FEBRUARY 2020

PL6

NON MATERIAL  
AMENDMENT  
PLANNING  
APPLICATION  
& CONDITION 4  
DISCHARGE

44 A GLOUCESTER  
AVENUE LONDON  
NW1 8JD

## 2.3 CHANGES TO CONSENTED DEMOLITION REAR AND SIDE ELEVATIONS

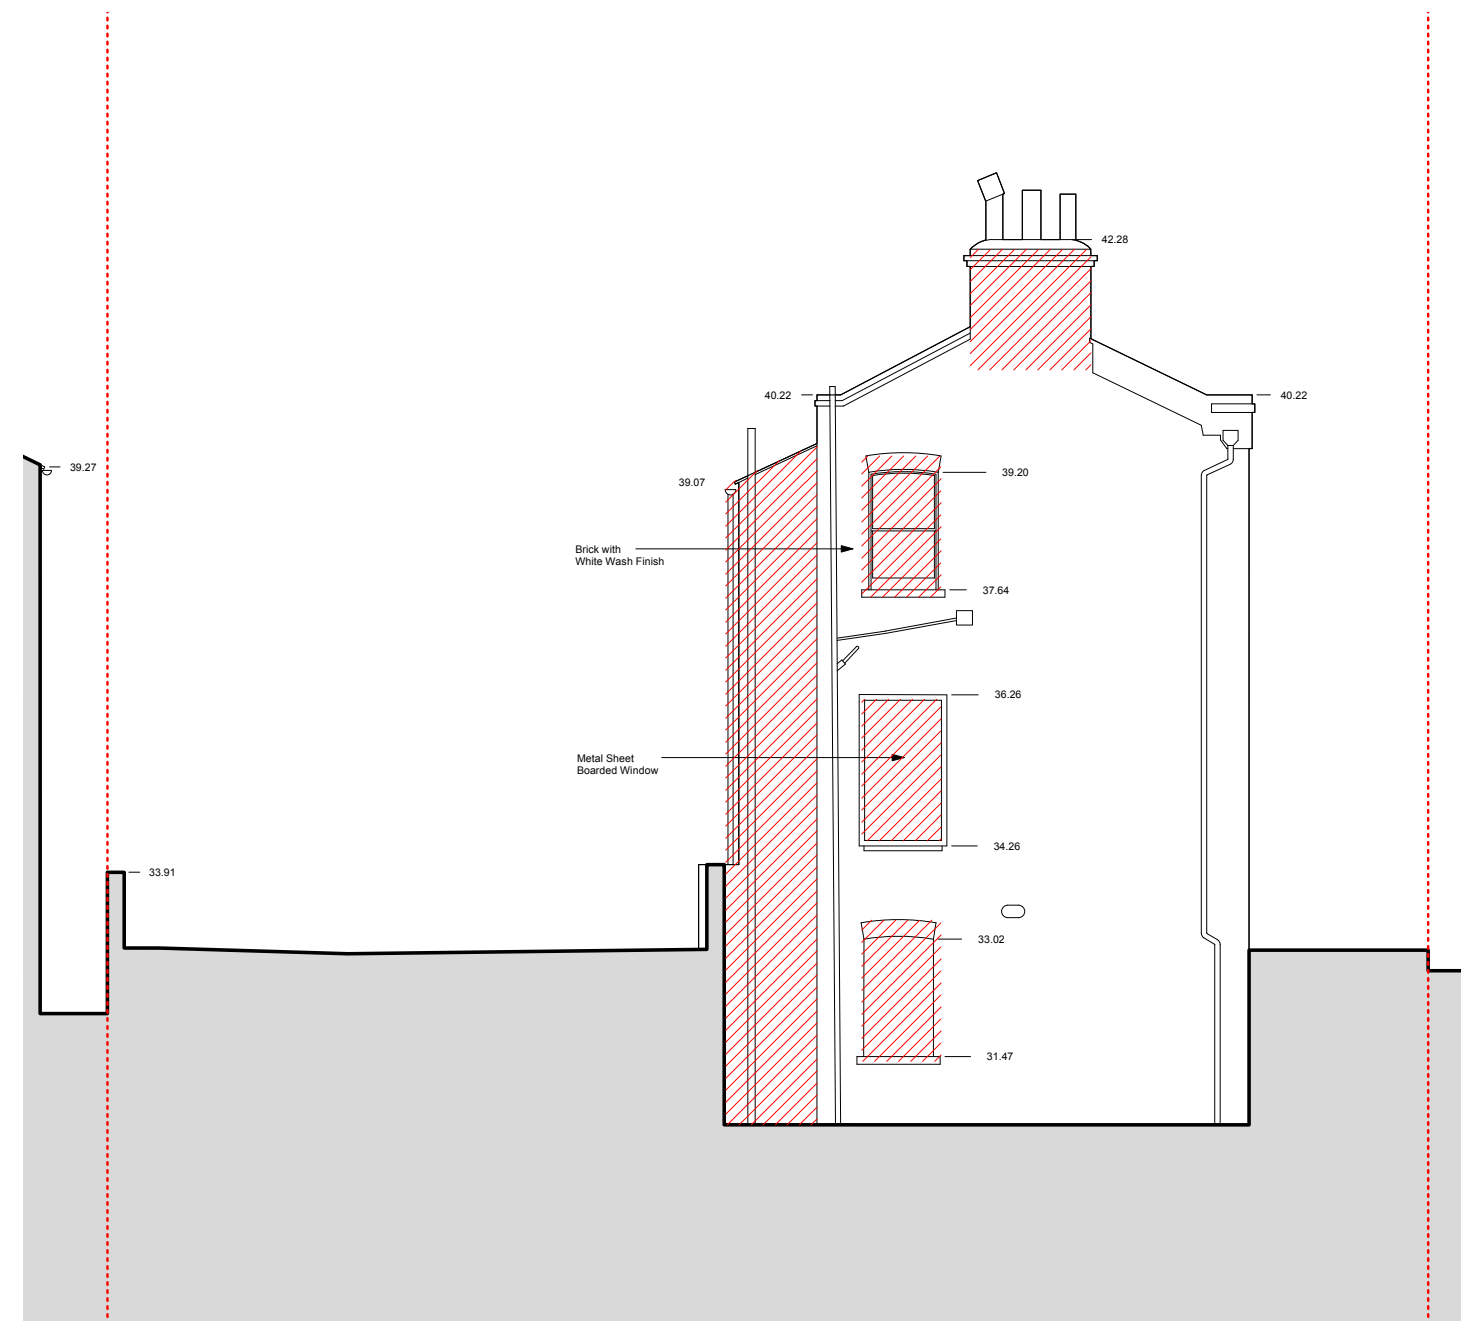
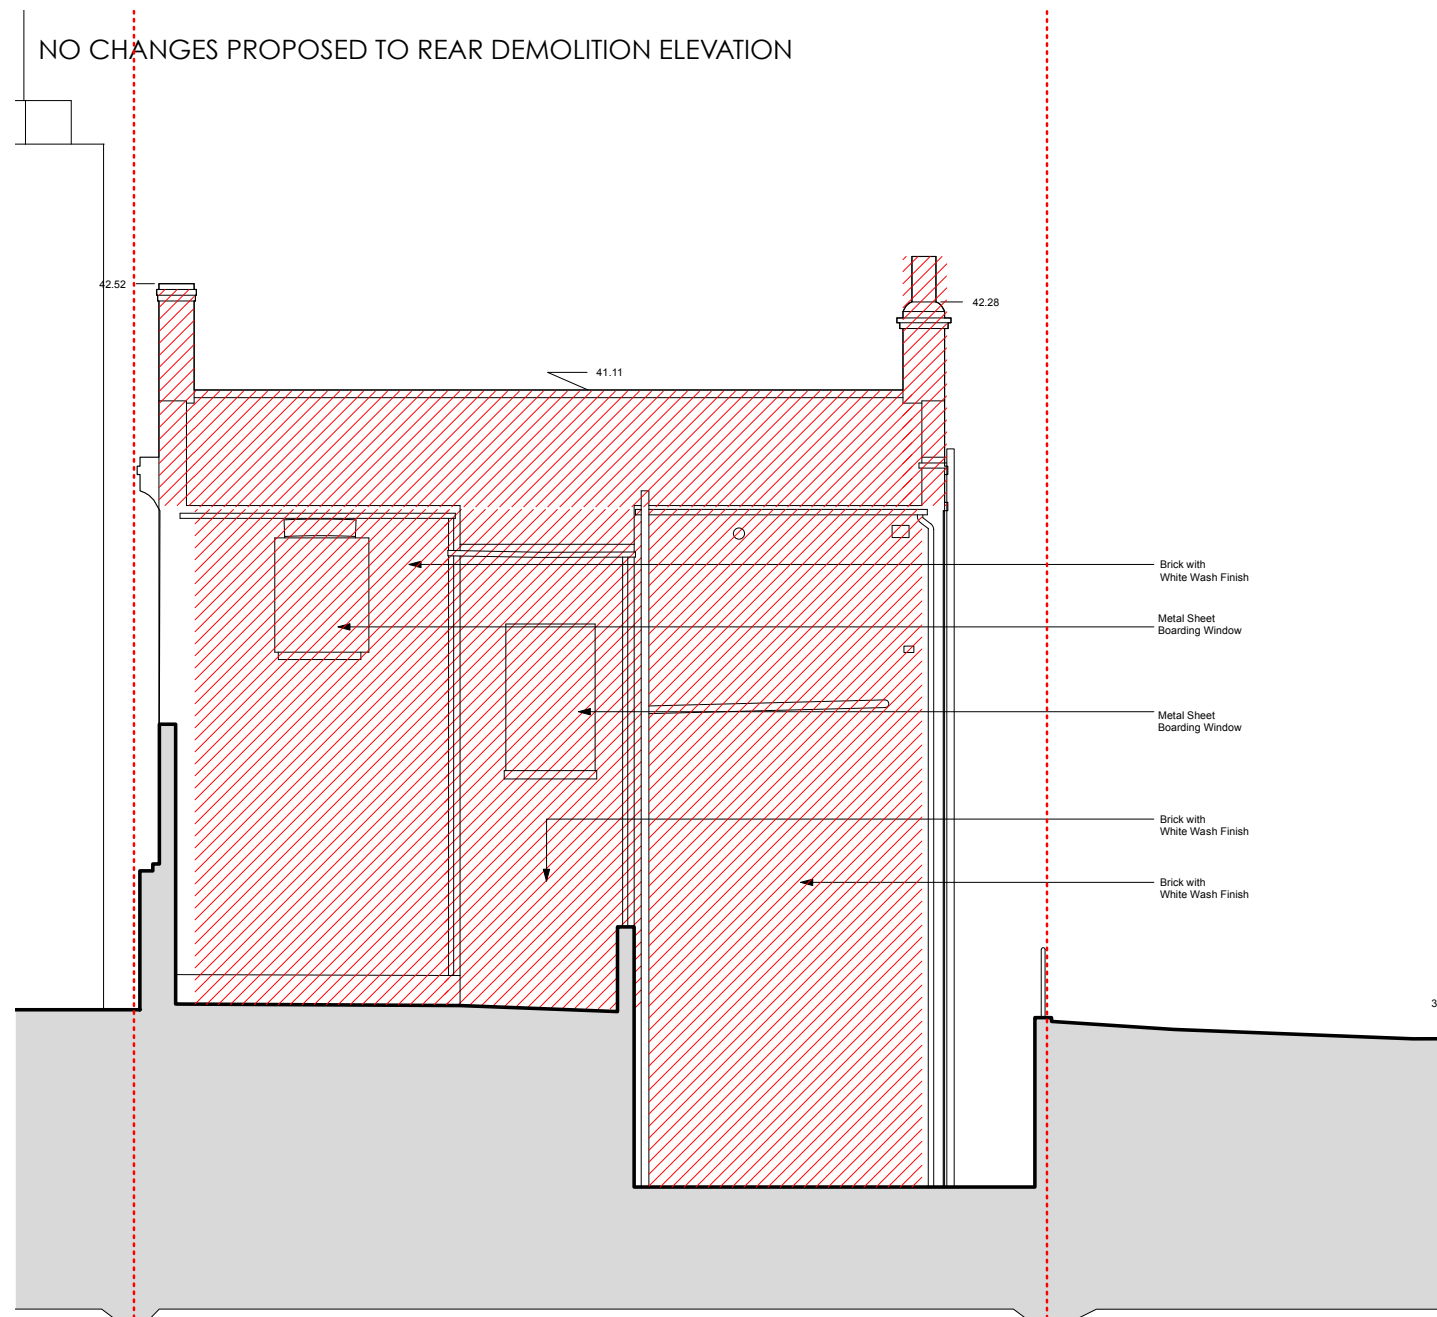
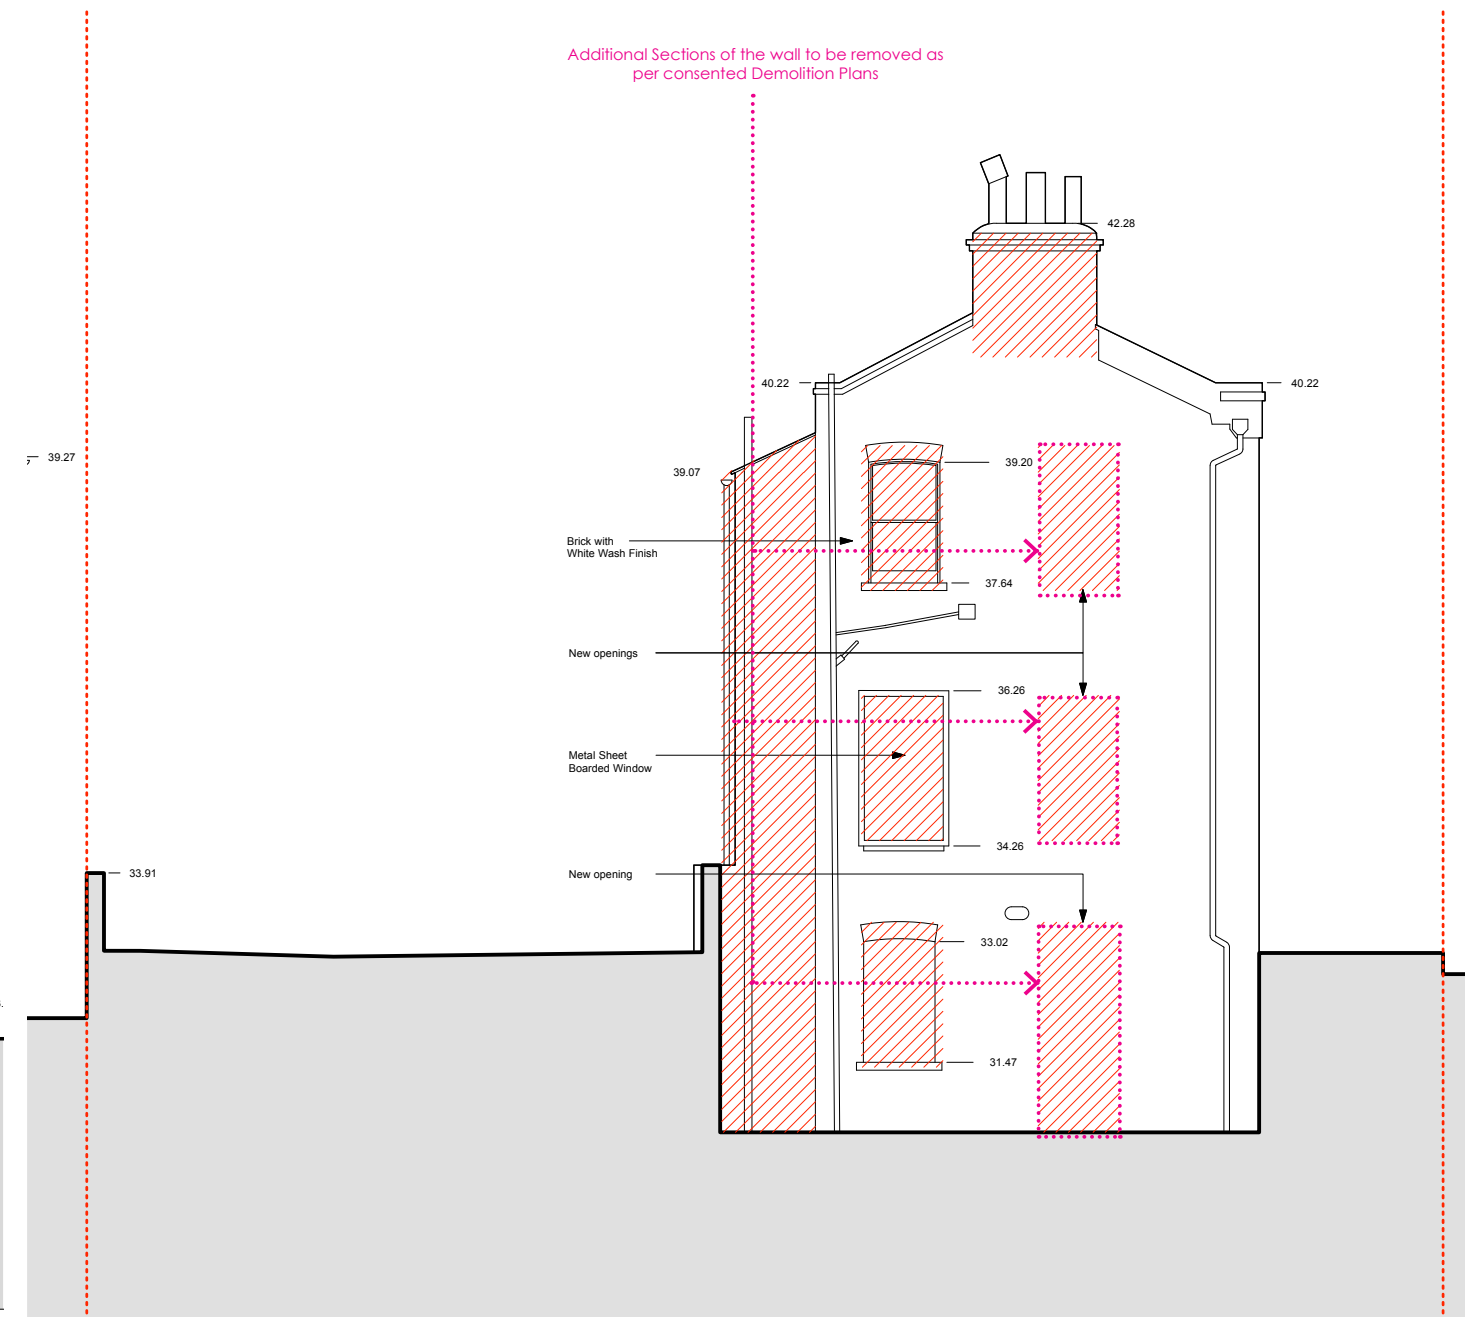
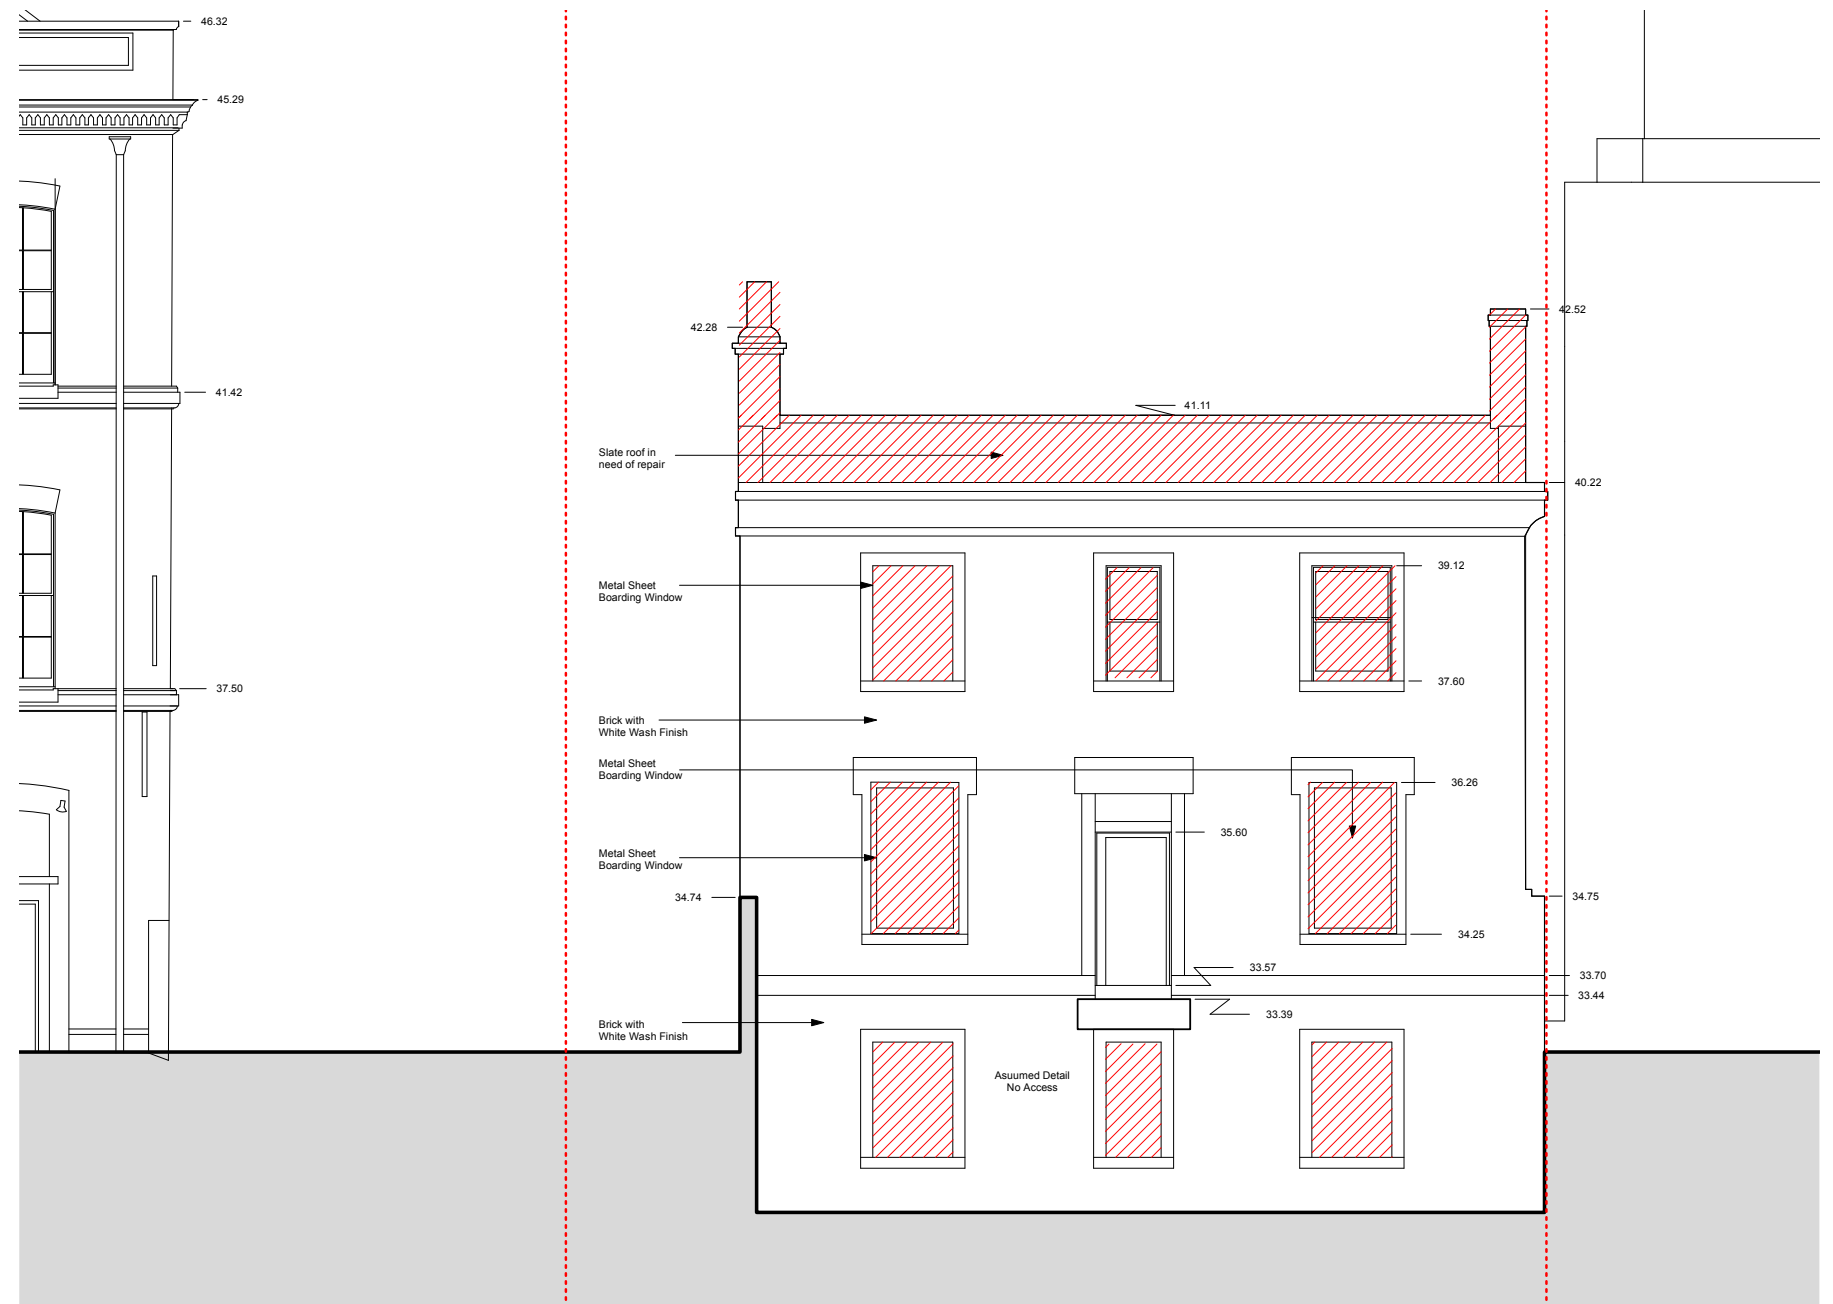
- Due to incorrect initial survey basement front balcony opening has been revised in the demolition drawings
  - Demolition drawings have been revised with correct openings in the side elevation and other minor changes
